ISSUE:	Permit to Demolish/Capsulate (partial) and Certificate of Appropriateness for alterations and addition.
APPLICANT:	Harry Mahon and Twig Murray
LOCATION:	Old and Historic Alexandria District 513 South Lee Street
ZONE:	RM/Residential Townhouse Zone

Docket #6 & 7 BAR #2021-00586 & 2021-00592 Old and Historic Alexandria District November 17, 2021

The applicant requests a Permit to Demolish/Capsulate (partial) and Certificate of Appropriateness to enclose a portion of the rear addition to add a pantry and storage addition as well as alterations, at 513 South Lee Street.

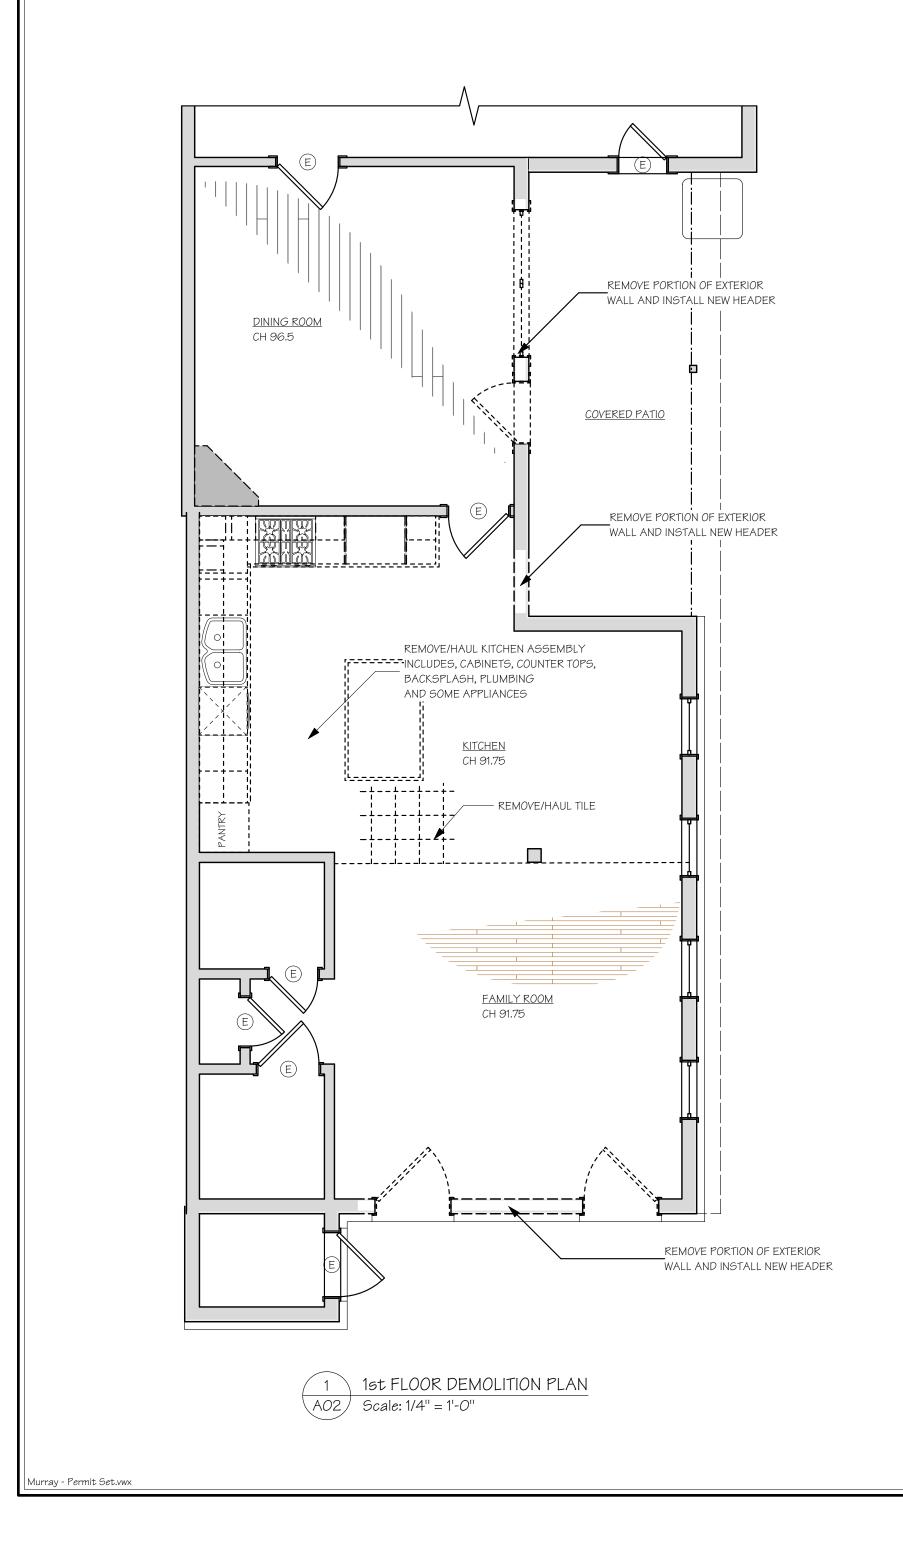
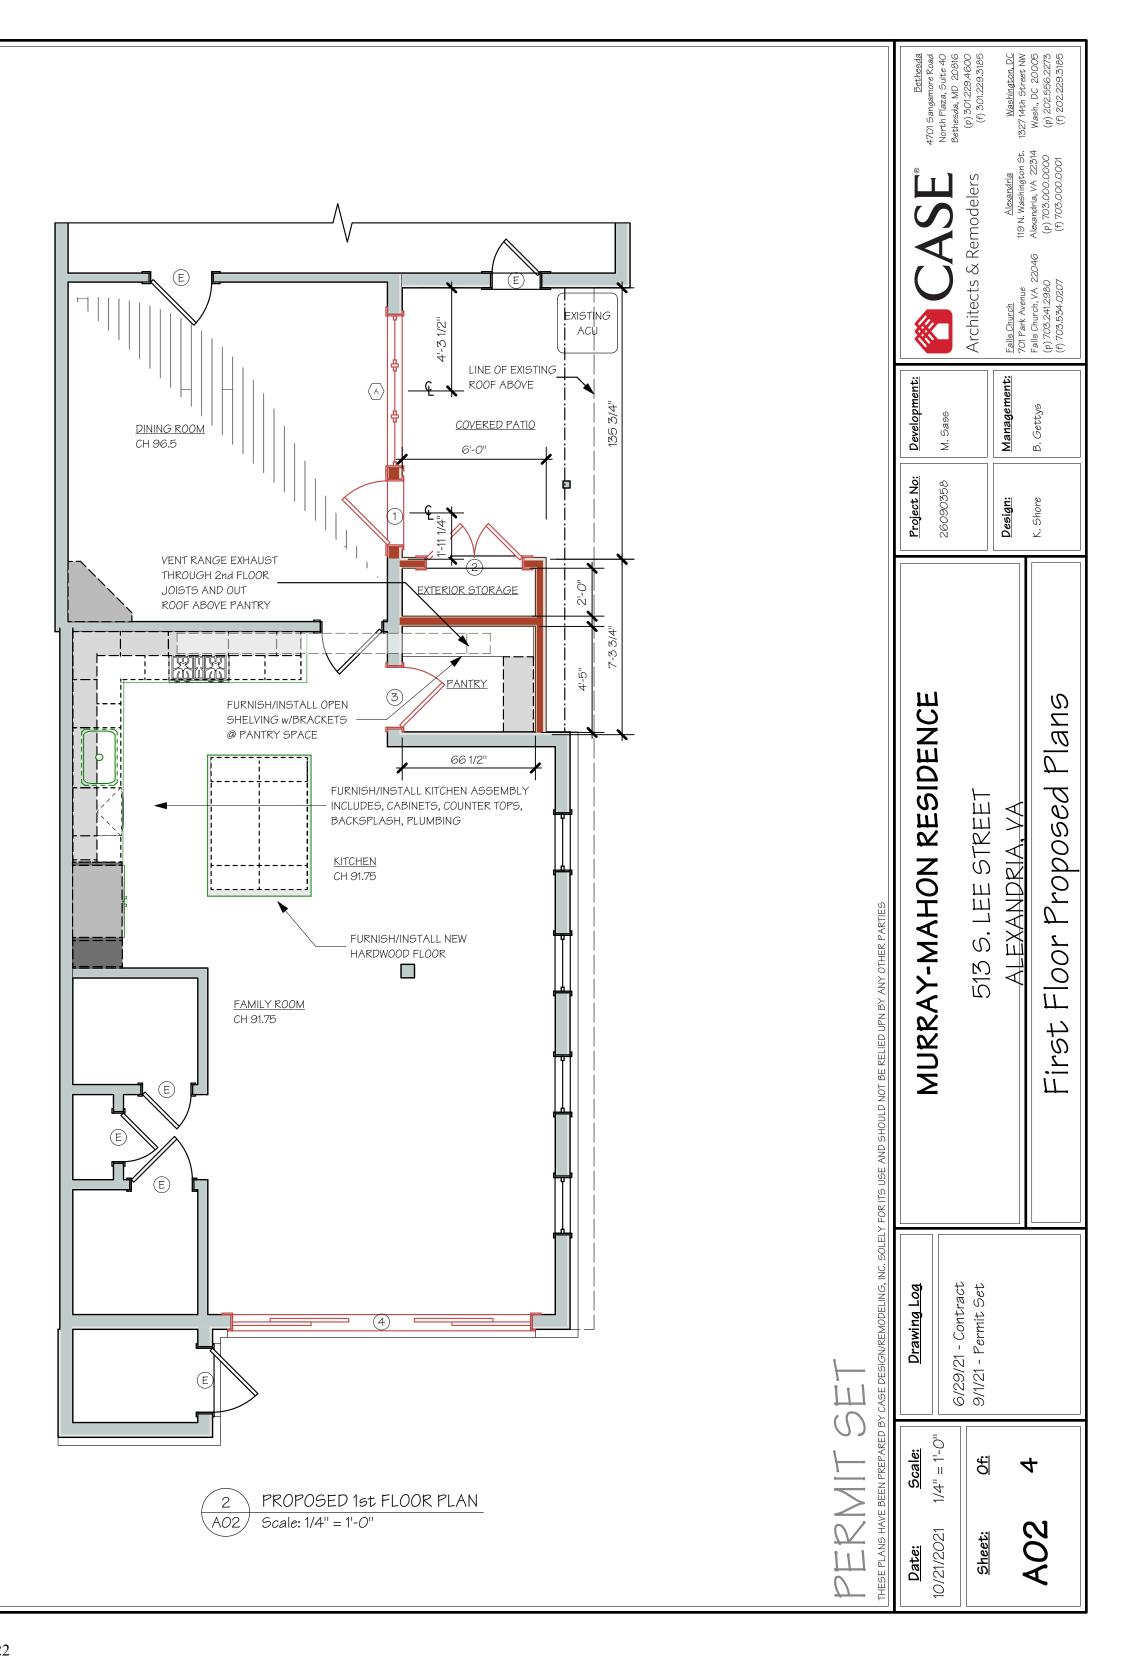
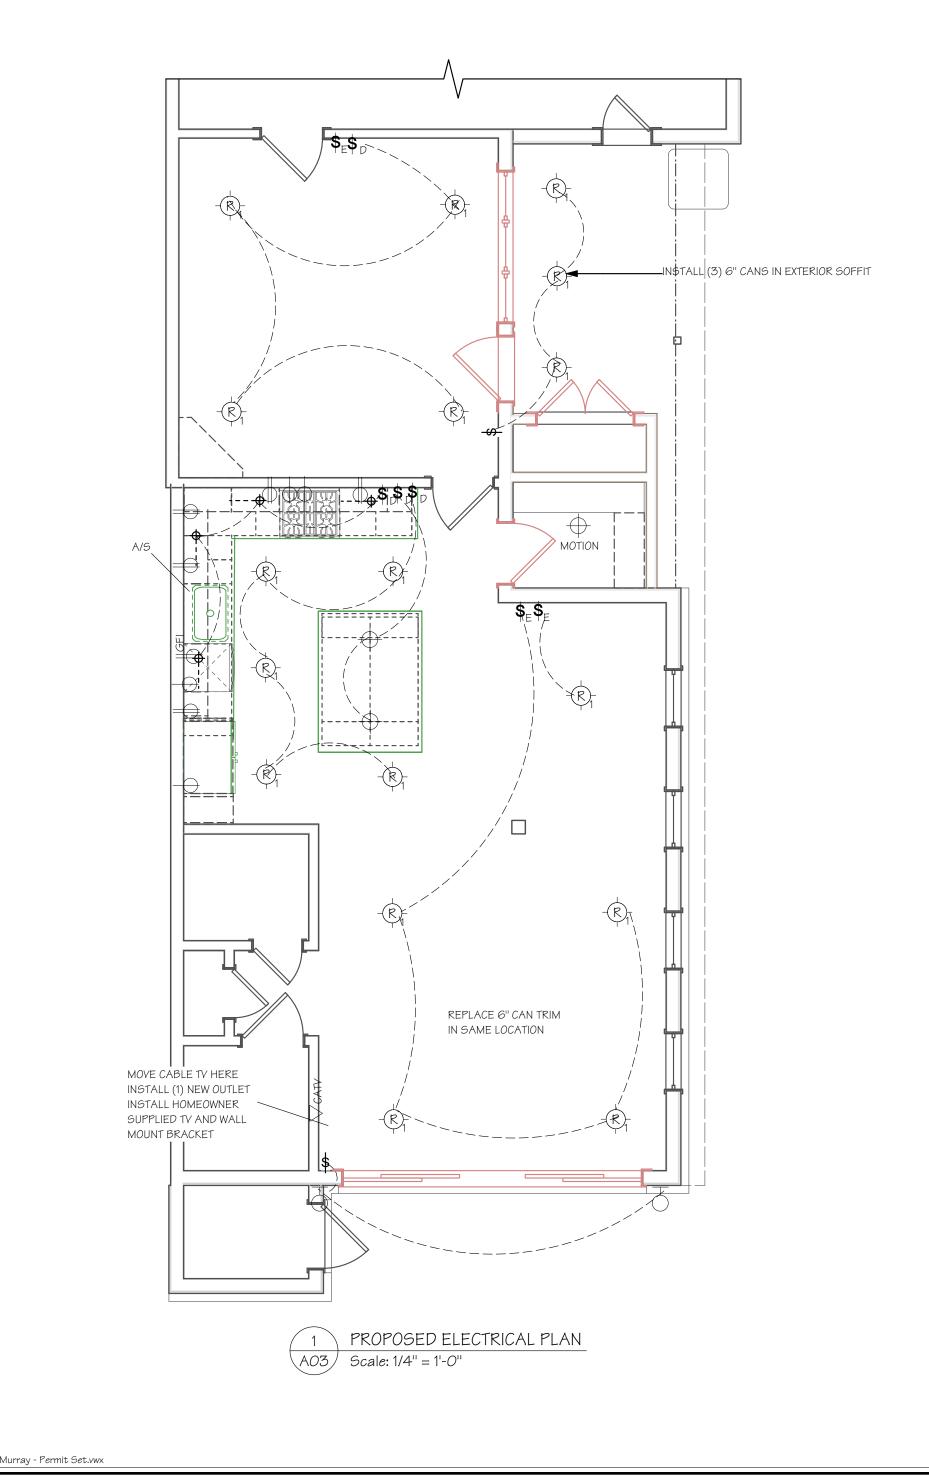
- 1. The new addition's HardiePlank siding be of smooth finish.
- 2. The statements below marked with an asterisk "*" shall appear in the General Notes of all site plans and on all site plan sheets that involve demolition or ground disturbance (including Basement/Foundation Plans, Demolition, Erosion and Sediment Control, Grading, Landscaping, Utilities, and Sheeting and Shoring) so that on-site contractors are aware of the requirements.

The BAR administrative approval policies state that "Buildings and additions constructed after 1931 may use fiber cement (e.g. HardiePlank) or composite (e.g. Boral) siding and trim with an architecturally appropriate profile, provided it has a smooth finish." Therefore, staff recommends the proposed addition's siding has a smooth finish.
